COUNCIL PANEL ASSESSMENT REPORT

Panel Reference	2017SNH084
DA Number	DA0610/17
LGA	Ku-ring-gai
Proposed Development	Demolition of existing structures and construction of a mixed use development comprised of shop top housing containing 56 apartments, use of ground floor commercial space as an Aldi supermarket and small retail suite, basement parking, signage and associated works
Street Address	810-818 Pacific Highway, Gordon
Applicant/Owner	RPS Group / Pacific Highway Gordon P/L & Ku-ring-gai Council
Date of DA Lodgement	11 December 2017
Number of Submissions	7 submissions in response to 1 st notification, 1 submission in response to notification of amended plans
Recommendation	Refusal
Regional Development Criteria (Schedule 7 of the SEPP (State and Regional Development) 2011)	CIV in excess of \$20 million Works on land to which Council has an interest in excess of \$5 million
List of all relevant s4.15(1)(a) matters	<ul style="list-style-type: none"> • SEPP 55 – Remediation of Land • State Environmental Planning Policy No. 64 • State Environmental Planning Policy No. 65 • SEPP (Infrastructure) 2007 • State Environmental Planning Policy (BASIX) • Sydney Regional Environmental Plan

Figure 4: Excerpt DA06 (E) Level 1 - unresolved impacts to streetscape and access as identified

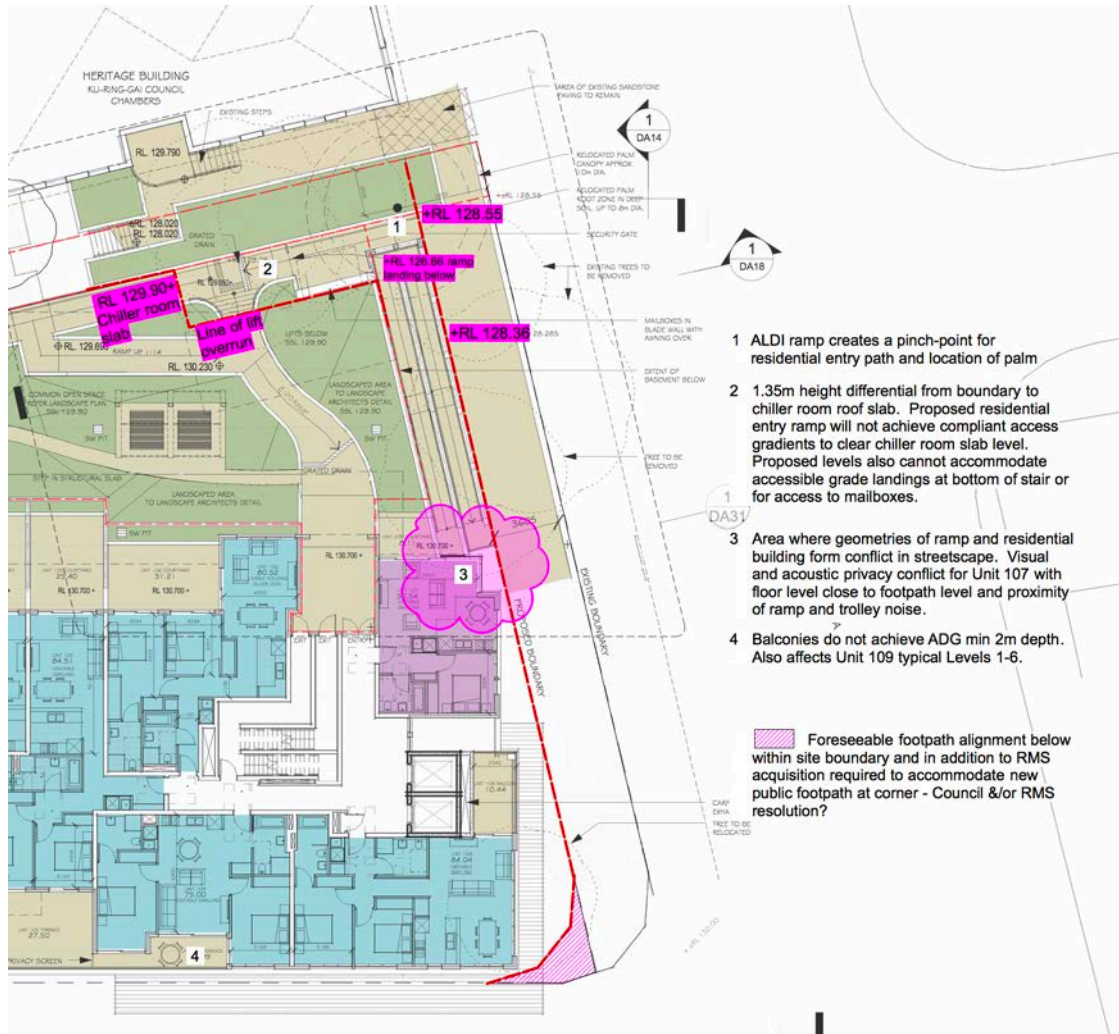
c) Relationship between the geometries of the ALDI pedestrian ramp and building mass of Unit 107 and above - is awkward. Resolution of the pedestrian ramp results in an awkward conflict at the junction of the ramp and building mass above that will be just above pedestrian eye-height. It will be prominent in the streetscape being at the most visible north-eastern corner and located on the new boundary line. This is largely a result of proposed floor levels of the ground floor supermarket and first floor residential above necessitating an excessively long ramp and resulting in a poor relationship of residential use to the ground plane in a B2 zone.

Figure 6: Calculation sheet for GFA showing much of the loading level is not included in the calculation of GFA but adds to the height and bulk of the building

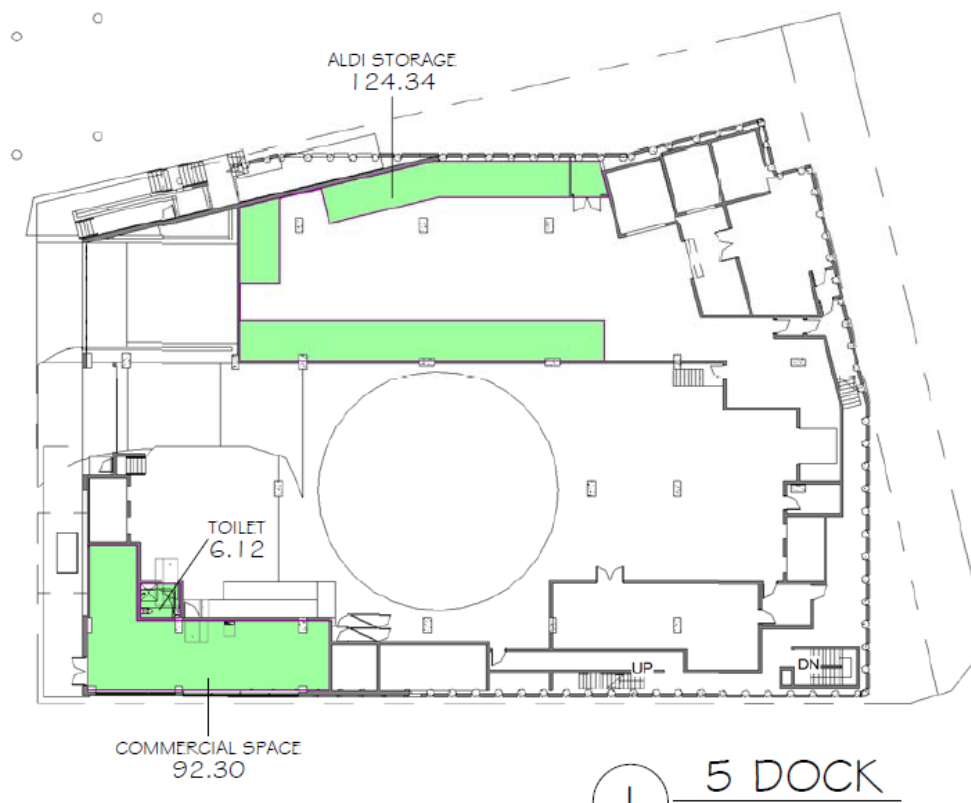
The second key element is that the application is for a supermarket. A supermarket, usually but not always, has a single large level floor plate which is difficult to achieve on a steeply sloping site and results in the design approach seen in the subject application of a supermarket which has a floor below the footpath level in Pacific Highway by up to 2.5m, above the footpath level in Dumaresq Street by up to 6.5m and above the footpath level in Radford Place by up to 7.2m. The use for a supermarket also requires significantly larger loading and goods handling areas than other uses in a mixed use development, which needs to be provided with significant floor to ceiling height to allow large trucks to enter the site. As can be seen in the following figure (figure 6) which shows the areas of the loading level of the development which are included in the definition of GFA, the significant majority of this level is excluded from the FSR calculation. As such, whilst the applicant is correct in stating the proposal is compliant with the FSR, simple compliance does not tell the full story in relation to the height and bulk of the proposed development. As can be seen from the rear elevation, the first 7m of height of the building is largely not included in FSR calculation, but it does significantly add to the height of the development.
